8020A-7601 LCD BRACKET CHANGE P/N 613398

SUPPLEMENT TO INSTRUCTIONS FOR

8020A-7601 LCD BRACKET CHANGE

P/N 613398

Figure 1.

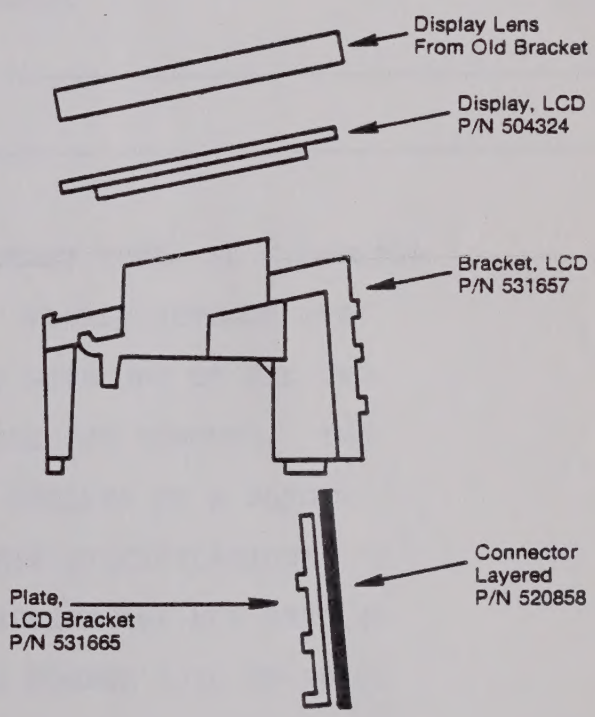
1. Remove the instrument from its case.
2. Remove the LCD Bracket and all interconnect parts by removing the two (2) screws holding the bracket to the PCB.
3. Refer to Figure 1 during the following assembly procedures.
   A. Install the new LCD, P/N 504324, into the new bracket, P/N 531657, by inserting it under the lip at the top edge of the new bracket.
   B. Install the Display Lens from the old bracket assembly.
   C. Insert the Layered Connector, P/N 520858, into the slot in the LCD Bracket.
   D. Insert the LCD Bracket Plate, P/N 531665, in front of the Layered Connector and snap it in place.
4. Install the assembled Bracket on the PCB in the same manner as the old bracket was removed.
5. Replace the PCB in its case and check for proper operation.
6. Complete instrument reassembly.

NOTE: If the LCD must be replaced at some later time it will be necessary to loosen the screws on the bracket so that the Layered Connector will slip down to allow the LCD to be inserted under the bracket lip.

INCLUDED IN THIS KIT ARE TWO DIFFERENT TYPES OF CONNECTOR STRIPS, PART #520858 and #453092. PLEASE REPLACE THE CONNECTOR STRIP IN YOUR INSTRUMENT WITH ONE OF THE TWO SUPPLIED, USING THE SAME TYPE AS THE ONE REMOVED. THE NEW CONNECTOR STRIPS ARE SUPPLIED BECAUSE OF A SLIGHT PHYSICAL CHANGE OF DIMENSION (WITHIN SPECIFICATIONS) OF THE LCD. THE PLASTIC MOUNTING BRACKETS ARE NOT USED IF REPLACEMENT LCD IS FOR FLUKE MODEL NUMBER 8010 OR 8012.
